Independent Technical Review of the Twin Pines Permit Application Hydrologic Modeling

Report Submitted to Fish and Wildlife Service

February 2023

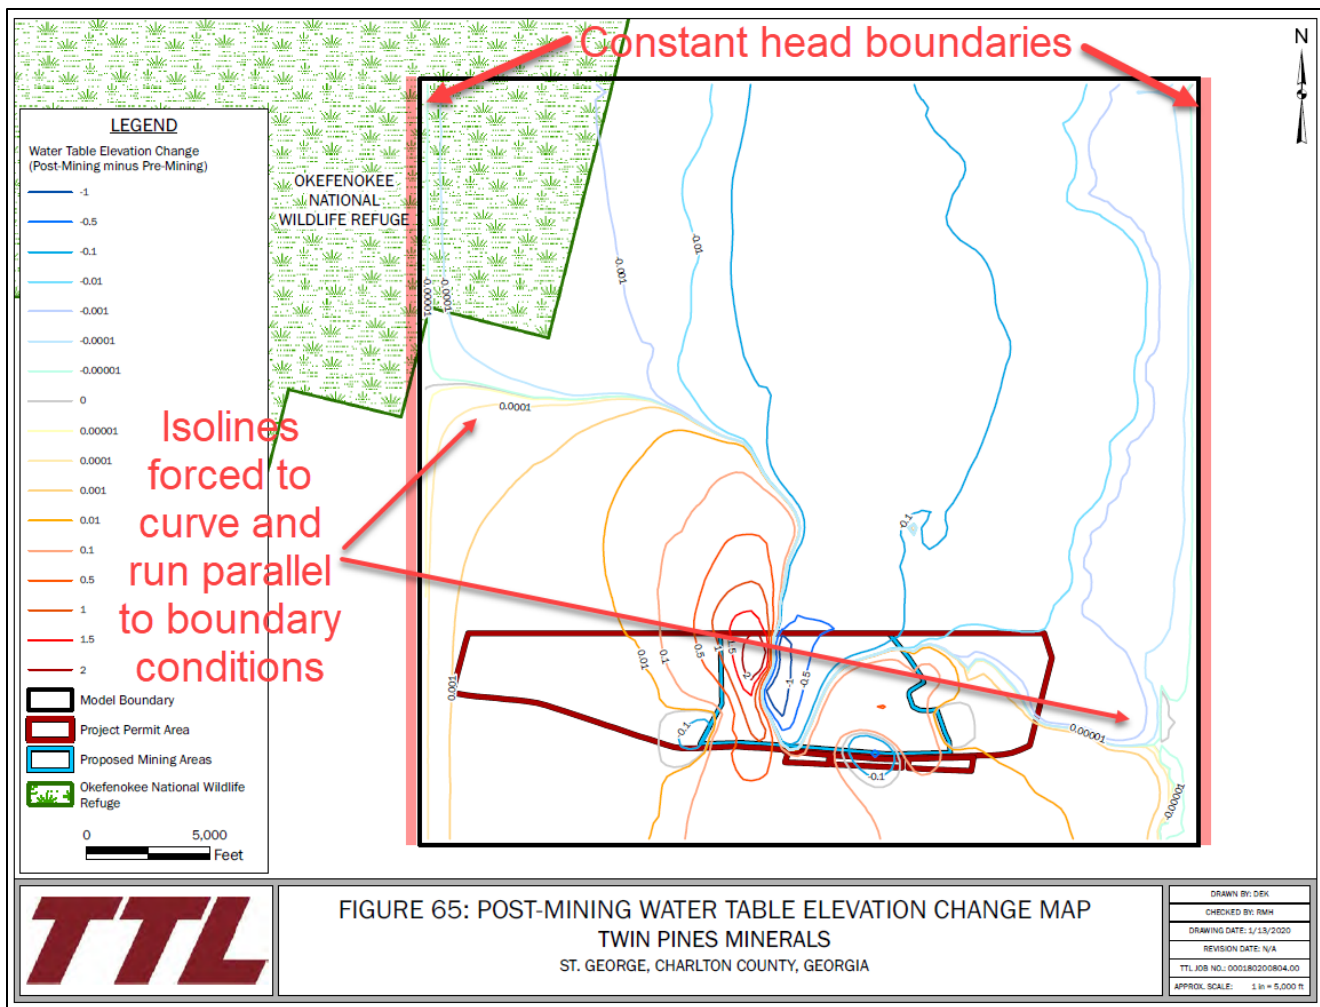
The goal of the simulations performed with these models is to quantify effects of the mine on water levels and flow volumes. When the east and west boundary water levels are set to a fixed value for all simulations, the differences between any two simulations along these boundaries will always be zero. This is especially concerning when we are quantifying effects in a ‘before’ and ‘after’ scenario because the difference between the scenarios is *forced* to be zero at the boundaries. This boundary effect also forces differences in cells *near* the boundary to be close to zero. The graph of stage differences between two model runs (Figure 14) illustrates this concept – the isolines showing differences in stage between two runs are forced to curve and then run parallel to the east and west boundaries and will always be zero. Constant head boundary conditions assume a constant water level at the boundary which is only valid where water levels don’t change over time. But in this mining site, there are seasonal fluctuations and variable land use, which create a variable water level at the boundary. So, this simplifying assumption doesn’t accurately represent the hydrologic conditions near the boundary and is also not suitable to assess the impacts on ONWR which is at the boundary of the model domain.

One cannot conclude that there will not be any effects on water stage in the areas of the model at (or near) the fixed-head boundaries of a steady state model.

Figure 15. Surficial aquifer potentiometric surface, showing how stage contours generally mirror land surface topography (Panday, Wyckoff, & Martell, 2021)

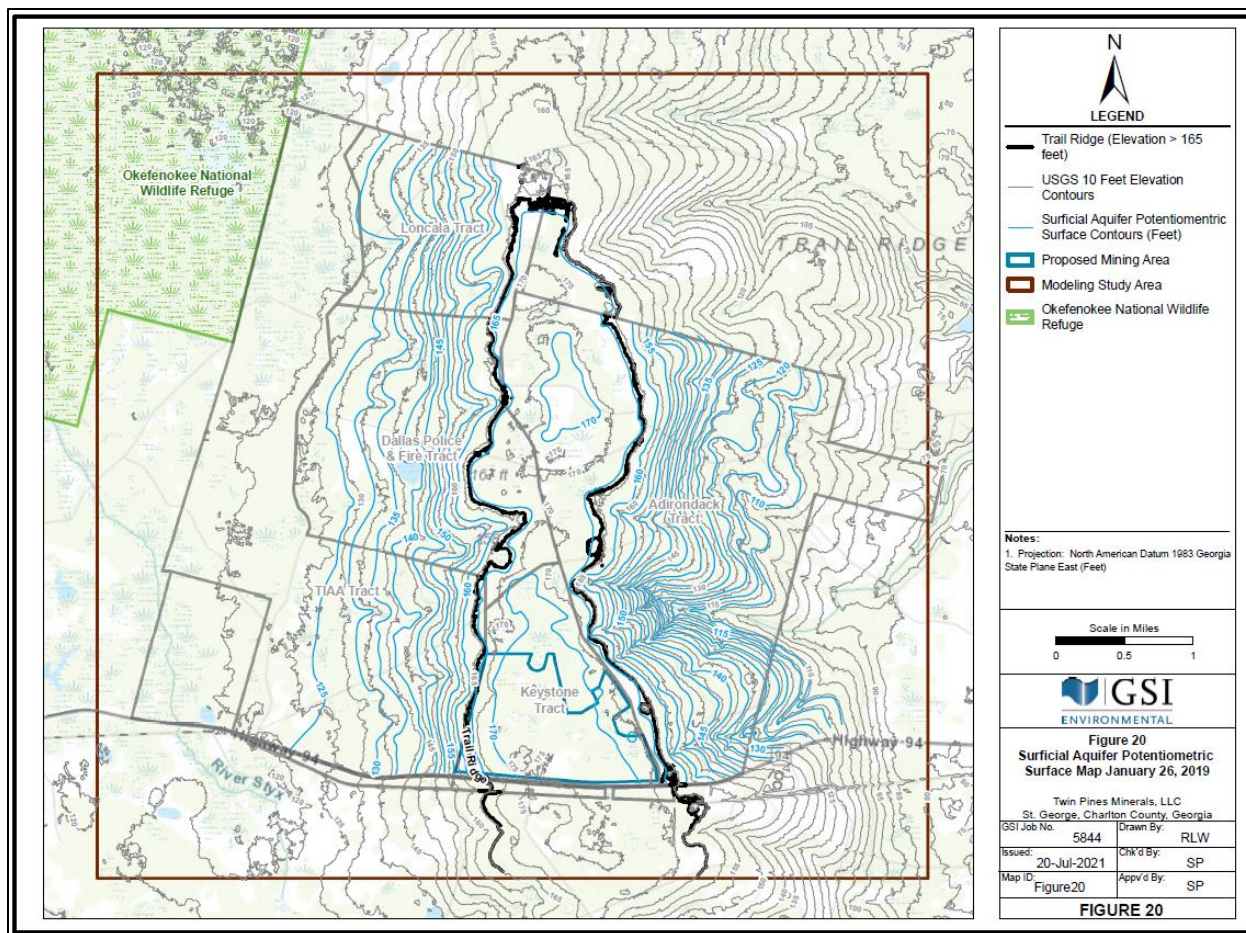
No-flow boundary conditions were used along the northern and southern boundaries of the MODFLOW soil disturbance and dewatering models. Lower groundwater levels exist outside the north and south model boundaries relative to the levels inside the model domain, because groundwater head contours mirror the surface topography in this area (Figure 15). This establishes an energy gradient from south to north across the northern boundary, and a gradient from north to south across the southern boundary of the model domain.

Because gradients exist there will be groundwater flows across these boundaries and “no flow” boundary conditions in the model are not appropriate. Any water that would flow out of the model domain across the southern boundary will be forced to flow out the east or western boundaries instead. Using this type of boundary condition causes water in the model to be redirected to places it would not normally flow.

Figure 16. Groundwater elevation vs. precipitation for station PZ-05, with precipitation measurements from stations RG-01, RG-02, and RG-03 (Holt R. , Tanner, Smith, Patton, & Lepchitz, 2019).

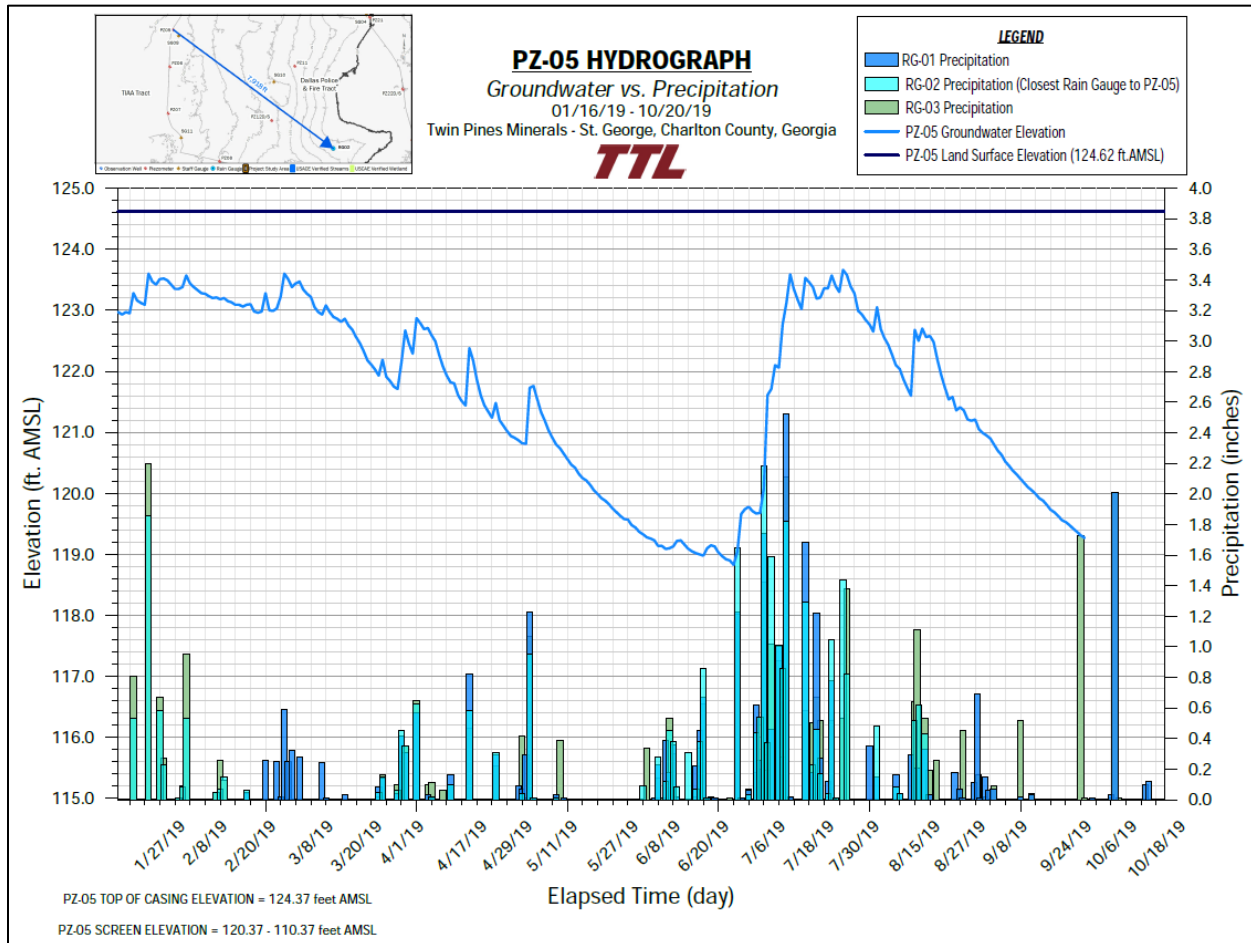
In addition, the average of 10-month groundwater levels used to calibrate the model is not sufficient to capture the seasonal and interannual variability (Figure 16). Datasets in nearby sites show a significant interannual variability in precipitation, evaporation, and recharge (see Figure 13). The response of this variability on groundwater levels is not captured with average values and steady-state simulations.

Figure 18. Map showing advancement of dragline in east-west direction (Twin Pines Minerals LLC, 2022).

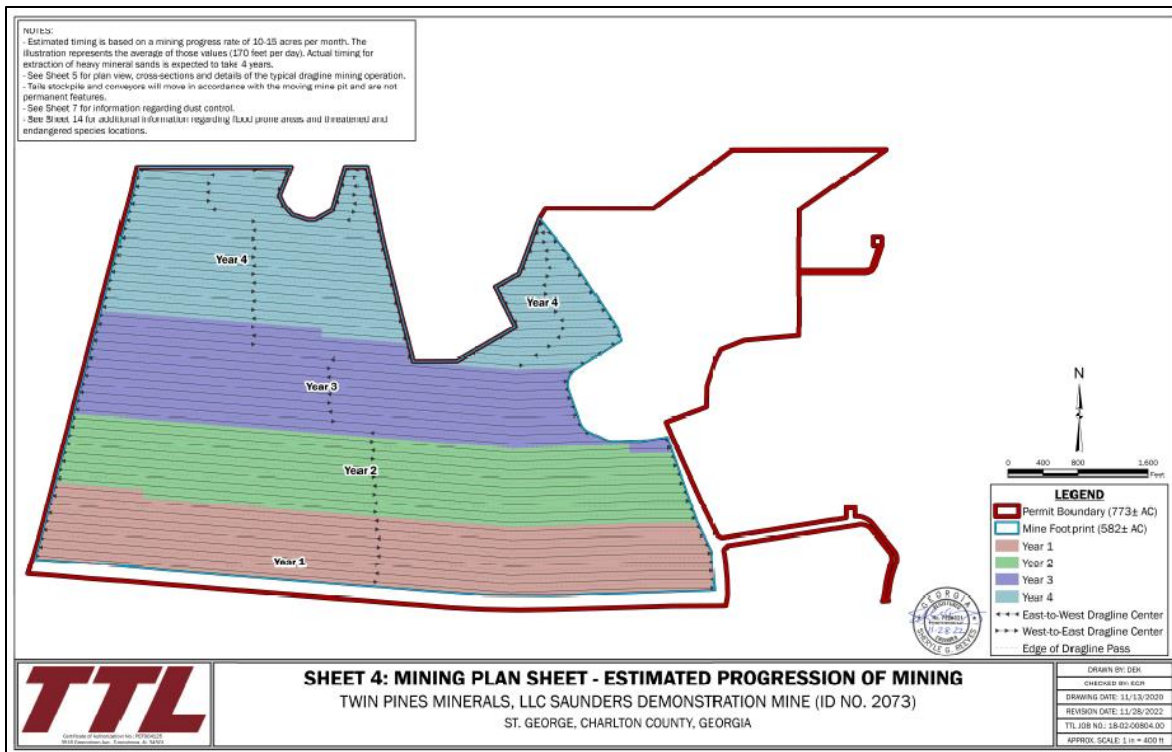
The Soil Amendment Plan (Twin Pines Minerals LLC, 2022) states that a bentonite amendment layer will be added as part of the reclamation process to re-fill the mine pits, if a black sand layer is found in the area before mining. Figure 18 shows how the dragline will proceed in east-west strips throughout the mining area. The mining pit operation will be preceded by exploratory drilling and followed by refilling of the pit. Re-filling might include the installation of a less-permeable subsurface bentonite layer, if a continuous black sand layer is encountered during the pre-drilling operation. If drilling does not encounter a continuous black sand layer, the re-filling operation will **not** include this less-permeable layer.

Figure 19. Cross-section showing how successive draglines will overlap with each other, causing overlapping sections to be re-mined (Twin Pines Minerals LLC, 2022).

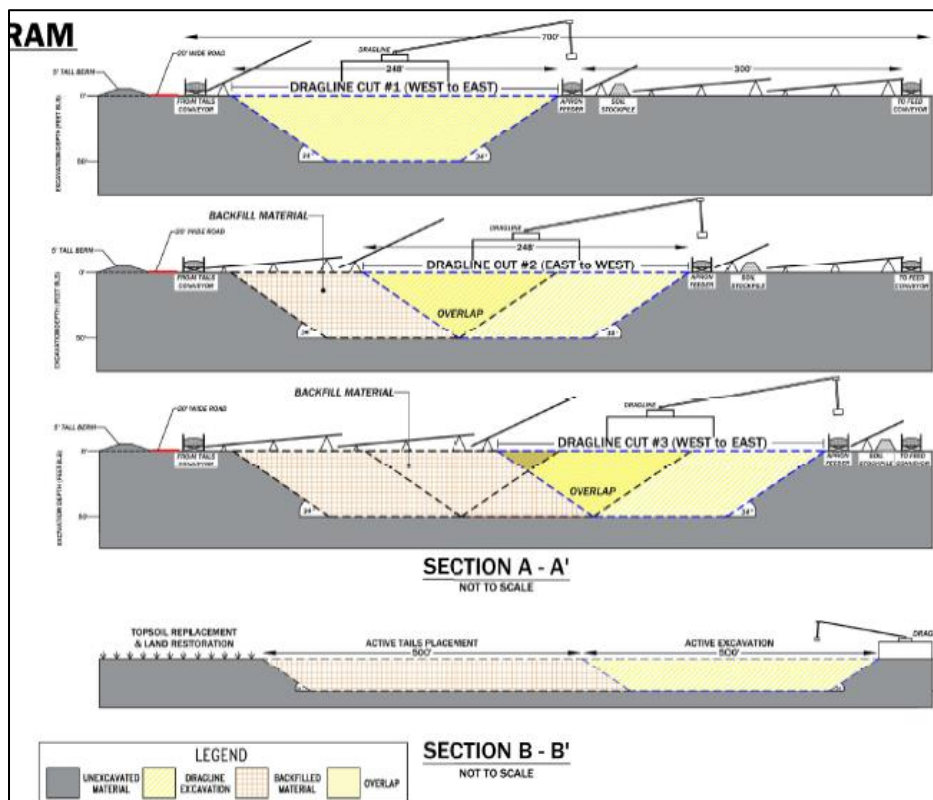
As the dragline proceeds, the mine pit will be re-filled with previously mined and mixed materials, along with potential placement of the new bentonite layer. Figure 19 shows how the successive draglines will overlap as the operation moves from south to north. This figure highlights how it will be necessary to re-mine and process overlapping areas for each pass. Some dirt will be dug up, mixed, and replaced during one east-west run, then dug up again, mixed, and replaced in the successive west-east run to the north.

From these drawings, it is clear that re-dredging of previously filled tailings will occur. Modeling assumed that transmissivity values for non-black sand layers would remain constant, but this does not seem possible given the tailings processing plan outlined in the application. If the bentonite layer is placed during one pass, then it must be partially *dug up again* in the next pass, over and over. As the mixing process of the tailings proceeds, any bentonite layer tailings will be mixed with the rest of the materials, and wind up being distributed throughout the entire vertical profile when the pit is re-filled. This could cause problems by altering the hydraulic conductivity of the sand layers above and below the bentonite layer. This will also make it difficult to calculate how much bentonite to add to achieve the desired hydraulic conductivity, because the 10.9% amendment ratio was calculated for sands *not* contaminated with bentonite.

Because this important feedback loop was not accounted for in the Soil Amendment Plan, it needs to be addressed before any permits are approved. It is also important to note that this reclamation process will be a *permanent* change in the system.
